OWNER:	TELANGANA STATE POWER GENERATION CORPORATION LTD. HYDERABAD - TELANGANA, INDIA			
CONSULTANT:	DESEIN PRIVATE LIMITED			
PROJECT:	BHADRADRI THERMAL POWER STATION 4 x 270 MW, UNITS-1 TO 4, MANUGURU, TELANGANA, INDIA			
EPC CONTRACTOR:	BHARAT HEAVY ELECTRICALS LIMITED INDUSTRIAL SYSTEMS GROUP ISG-BANGALORE			
TITLE:	G.A OF TP-3 WITH LOAD DATA			
SCALE:	BHEL JOB NO. IS-1-14-2007			
	BHEL-ISG IS-1-GA-691-104-M021 DRG.NO.:			
				REV. 01

COMPLIANCE TO COMMENTS OF DESEIN

ON GA DRAWINGS OF TP-3 R0 SUBMITTED BY BHEL FOR APPROVAL

Ref:	Comments made on GA Drawing prints of TP-3, IS-1-GA-691-104-M021, R0 by DESEIN		
SL NO	DESEIN COMMENTS.	COMPLIANCE / CLARIFICATIONS BY BHEL	REMARKS
	COMMENTS MARKED MEMO		
1	Monorail shall be projected 3 m from the out side sheeting of the transfer tower. Please correct.	Noted & revised.	
2	Please indicate the down comer and tramp iron chute clearance from the ground level.	Indicated	
3	Please include details of 1 ton hook provided at various places in the hoist schedule.	In hoist schedule, only details of hoist will be indicated. However, capacity & location is indicated in resp plan & elevation view & same shall be taken care by our civil in drgs.

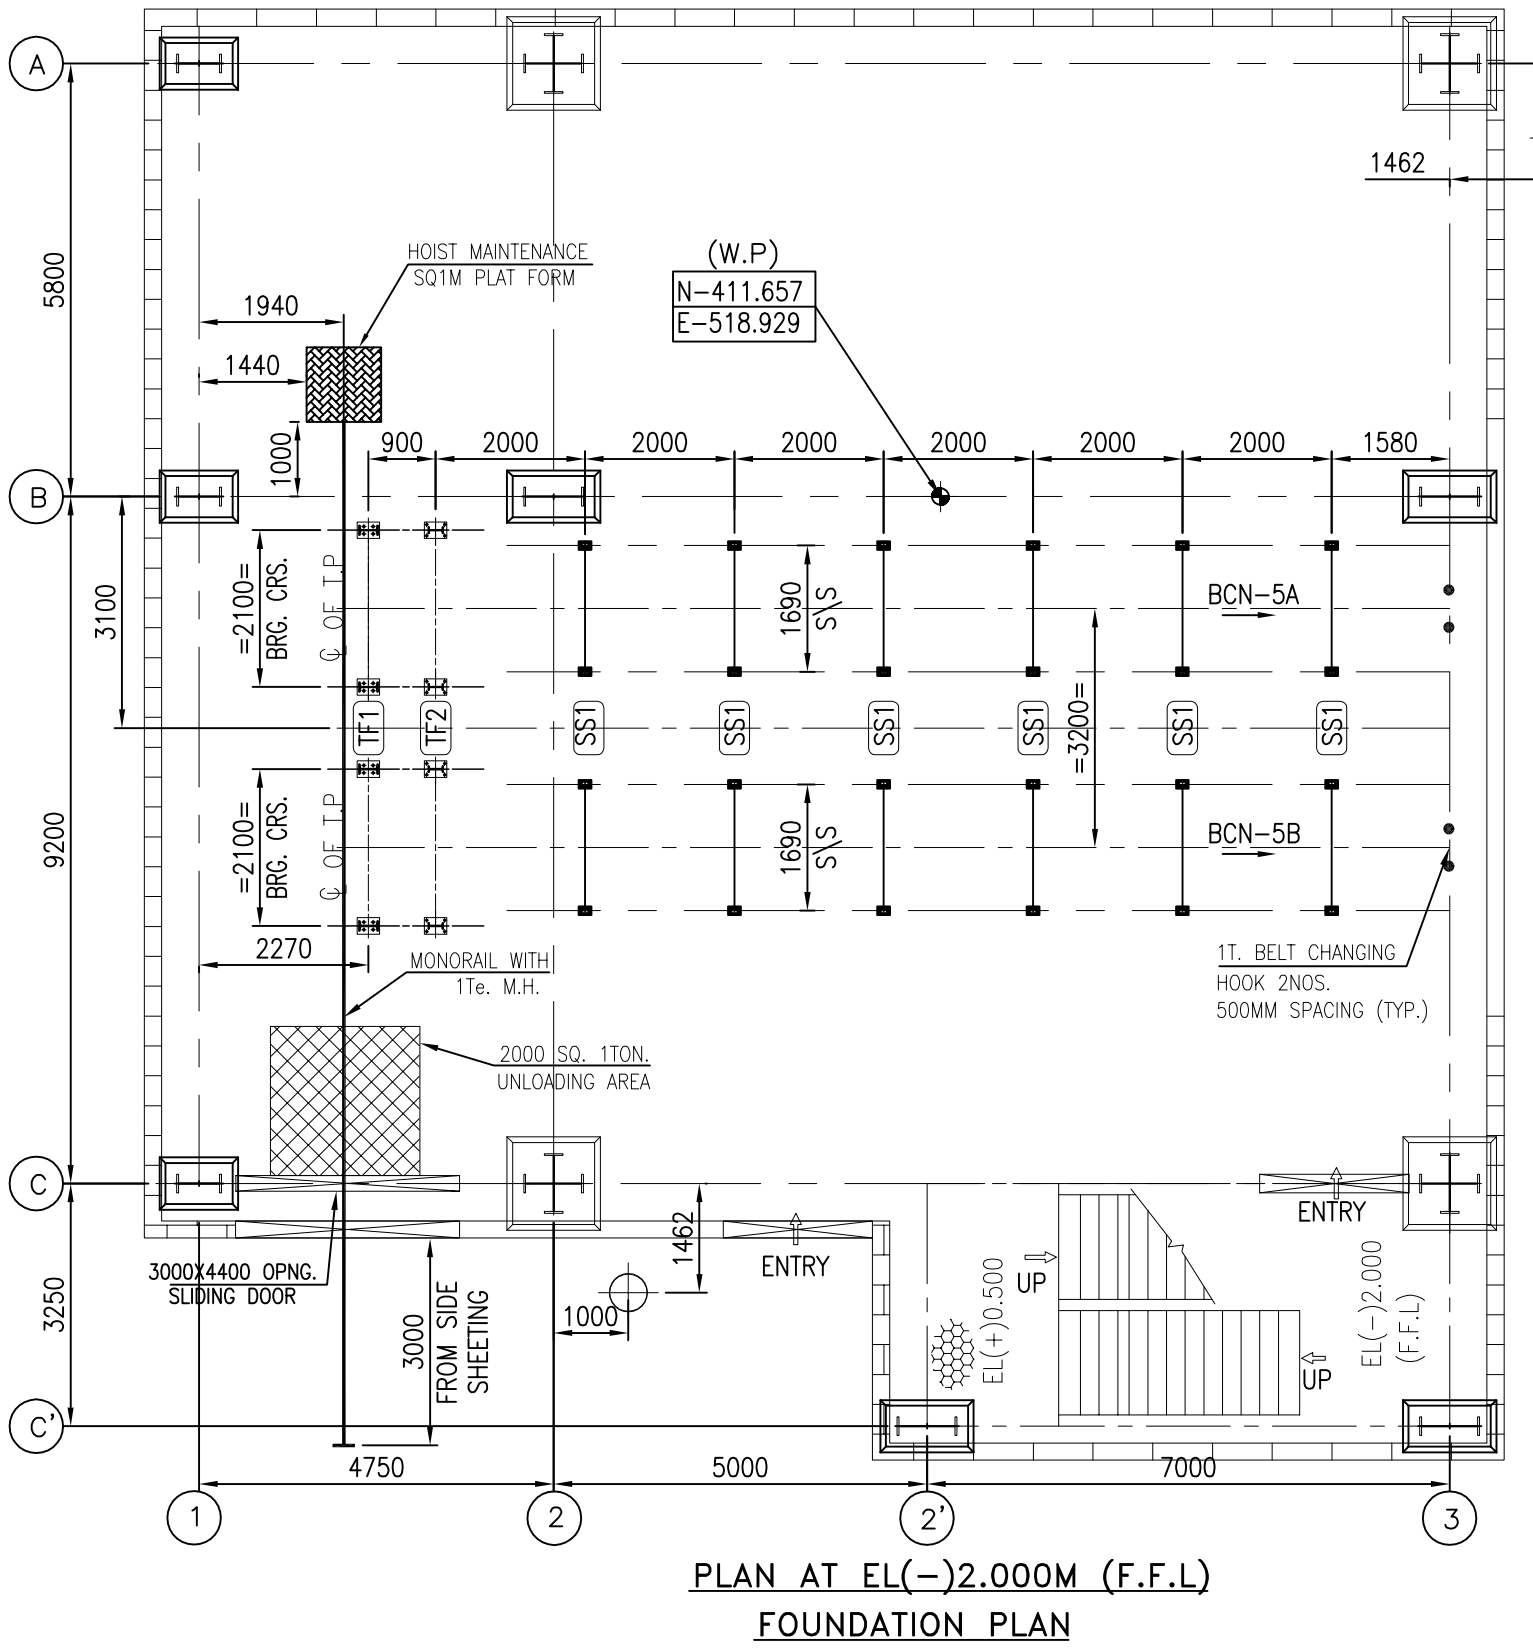
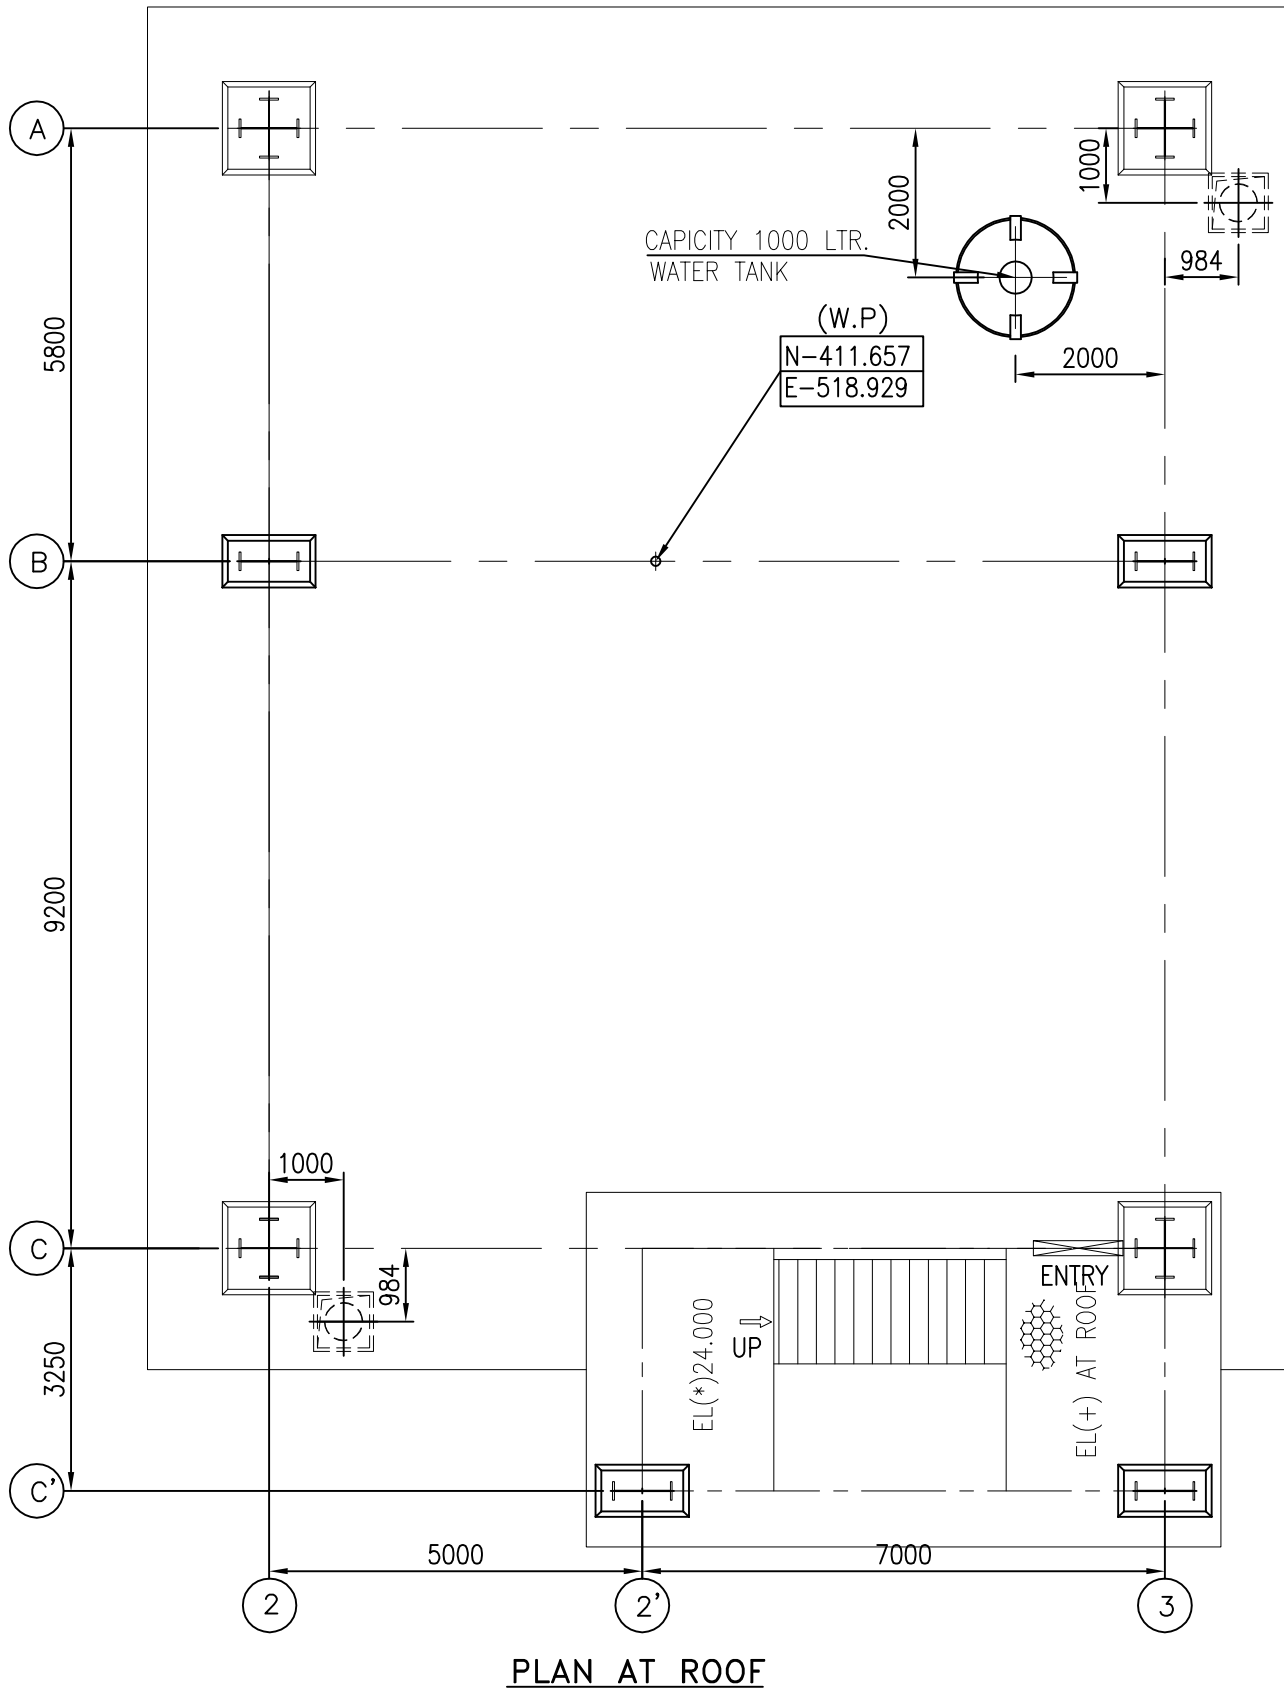
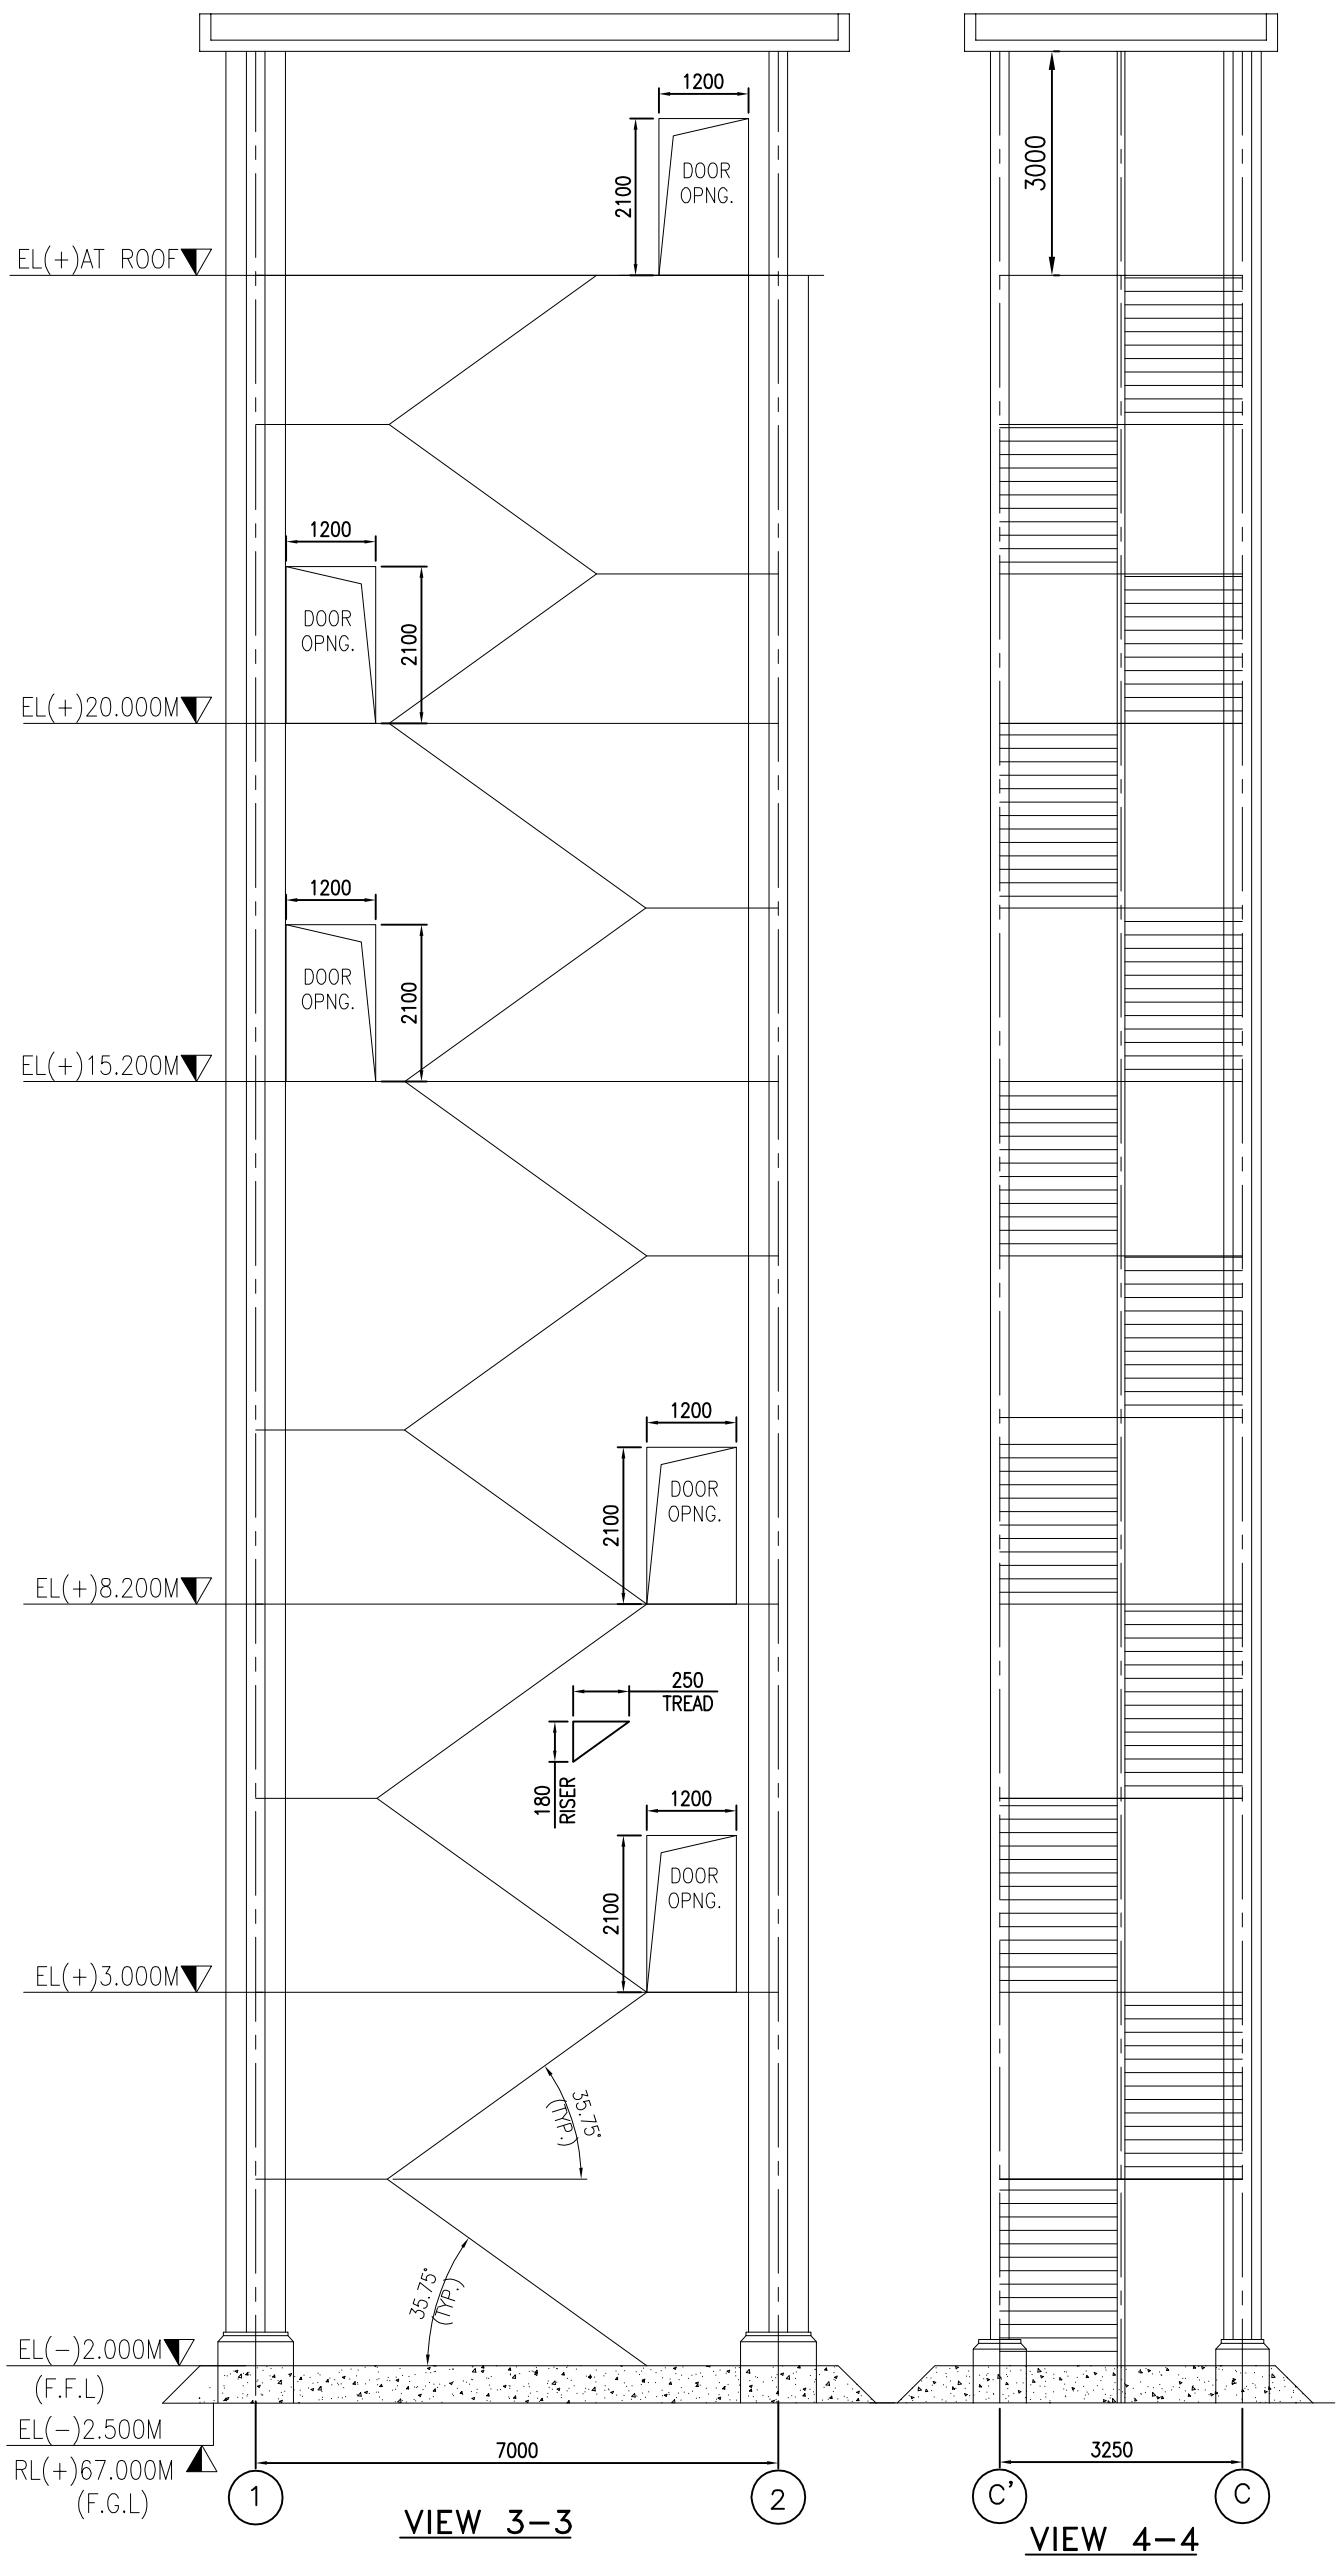
6	Please submit power tension calculations of BCNs coming in the transfer tower along with the GA's.	Already submitted.	
7	Please provide a note that curb wall will be provided around all openings	Noted & revised.	
8	Please provide side cladding details, equipment list along with their loads.	Shall be furnished in respective drgs. of civil / structural drgs.	
9	Please indicate chute vibrators and provide its details.	Indicated	
10	Inspection doors shall be leak proof. Please add	Noted.	
11	Anchor bolt plan may be corrected as foundation plan as not anchor bolt details are shown.	Corrected	
12	Refer machinery and anchor bolt plans: Please indicated the type of floor.	Indicated	
13	Please indicate height of skirt board and projection of skirt board in forward & reverse direction & give dimension.	Indicated	
14	Please confirm monorail routed is passing over CG of equipments to be handled.	Whereever possible to maximum extent, monorail routing has been done.

15	Openings for debris chute, DS/SW/DW pipes etc to be shown in all floors.	Indicated	
16	Please indicate north orientation in all the drawings.	Indicated	
17	Please indicate all the distances from the working point	Indicated	
18	Water tank shall be provided on a pedestal. Please indicate the same.	Indicated	
19	Please check and correct the angle of T.I in conveyors.	Indicated inline with already conveyor drgs. submitted.	
20	Refer GA of TP-3- Plan at EL(+)3.000M: Roof above the tail end of the conveyor shall be indicated.	Indicated
